# Access Compliance Report Public Rights-of-Way (Curb Ramps)

Main Street: MCGWIRE\_RD Cross Street: N/A Location: N

ADA ID: RPRK211025130825 Ramp Type: Type 1 - Perpendicular Diagonal Initial Pass/Fail: Fail Overall Compliance: No Severity Score: 45

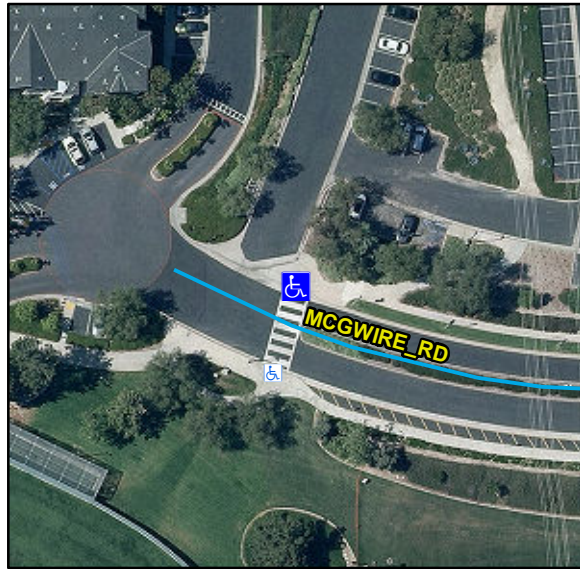
R304.2.2, R204.3, R304.5.3, STD 1115

| Compliance | Description                           | Data | Compliance | Description                   | Data |
|------------|---------------------------------------|------|------------|-------------------------------|------|
| No         | Ramp Run Slope (%)                    | 15.1 | N/A        | Flare Slope LT (%)            | N/A  |
| No         | Ramp Cross Slope (%)                  | 6.1  | N/A        | Flare Traversable LT          | N/A  |

Remove & Replace Curb Ramp With Two New Directional Ramps or Equivalent.
